October 7, 2009

Dr. William Shack  
Chairman  
Subcommittee on Material, Metallurgy & Reactor Fuels  
ACRS U.S. Nuclear Regulatory Commission  
Washington, D.C. 20555-0001

**Final Report**  
**on**  
**Review of Oyster Creek Generation Station**  
**3-D Drywell Confirmatory Analyses**

**Figure 1 Approximation of buckling mode shape**

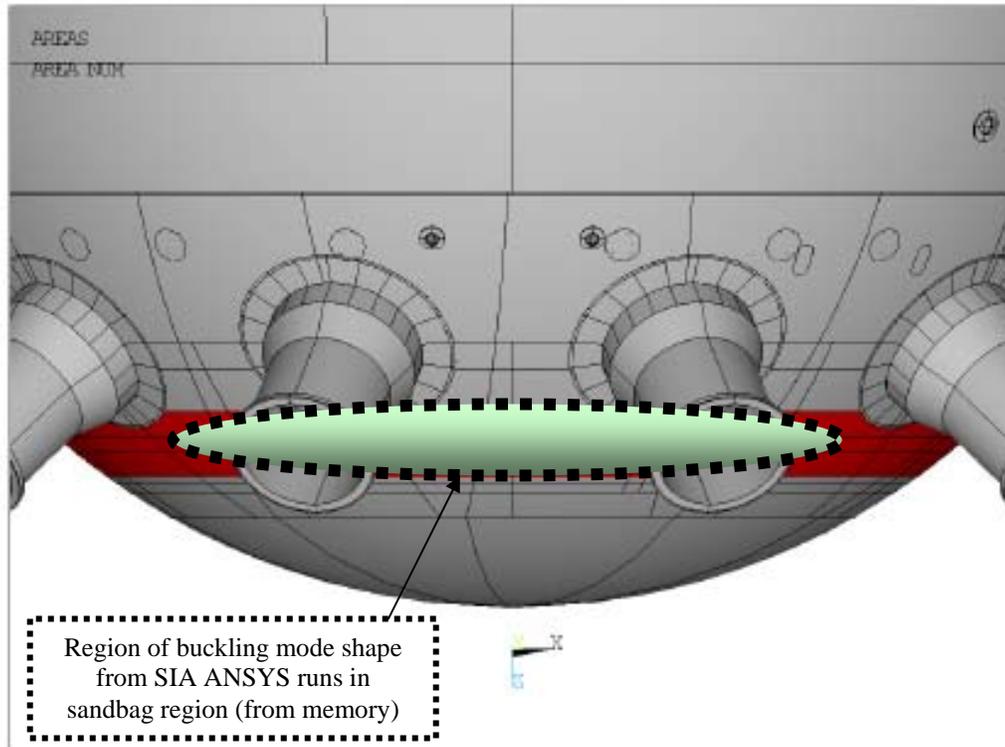
Because a full finite element model of the entire drywell shell was developed and modeled, buckling concerns of the entire shell (not just the corroded areas) were considered. However, many of the 200 buckling modes were in areas of the model that did not have degradation and there were low load participation factors. Exelon also said that not all of the loads in the toroidal area and vent lines were included in the model, so buckling modes in those areas are not relevant. It would have been of great assistance to have some comments added to the buckling mode tables (8-2 and 8-3 in SIA January 2009 report) that noted where the buckling occurred, or elimination of non-relevant buckling modes. Furthermore knowing the shape of the buckling modes of primary concern is quite helpful in understanding the thickness sensitivity studies. Having a copy of the pertinent buckling shapes from the SIA work is desirable. (Those mode shape figures were passed around at the September 29<sup>th</sup> meeting to the ACRS staff and G. Wilkowski, and Figure 1 is an attempt to illustrate the buckling mode shape of interest.)

**Figure 2** Thickness reduction measurements, SIA idealized circular reduced thickness areas, and blue dashed ellipses suggesting larger local thinned regions

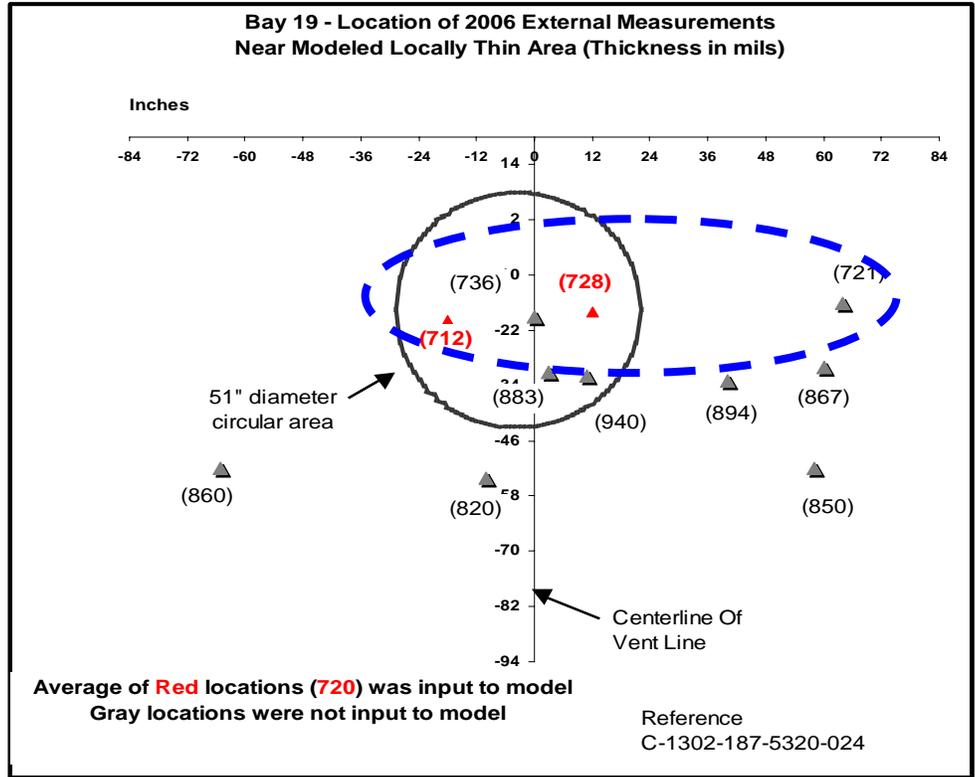
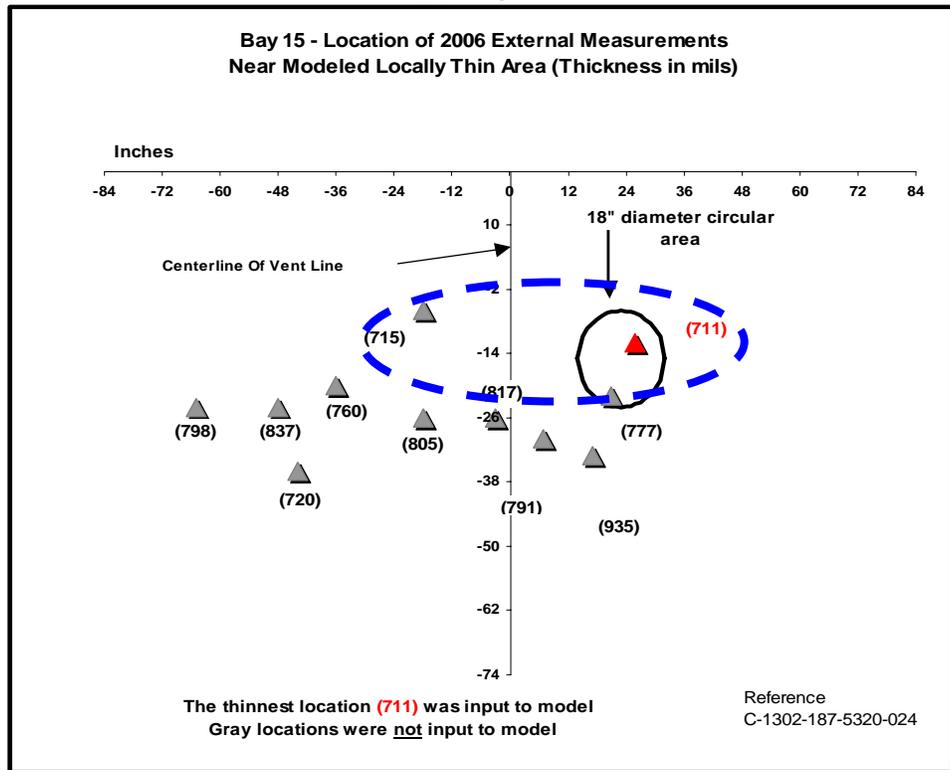
In regards to the thickness measurements and how they were modeled, at the September 23, 2009 meeting several of the ACRS staff members and the EECL presenter noted (as I did) that some of the thickness measurement plots in the Exelon presentation suggested that the thinned region might be more elliptical in shape (longer in the circumferential/horizontal direction) than the circular areas used in the SIA FE model. In particular this could be seen for Bay 19 (VG 26) and Bay 15 (VG 29). These longer elliptical shapes (illustrated in my Figure 2) would be in the same direction as the buckling mode shape in the sandbag region.
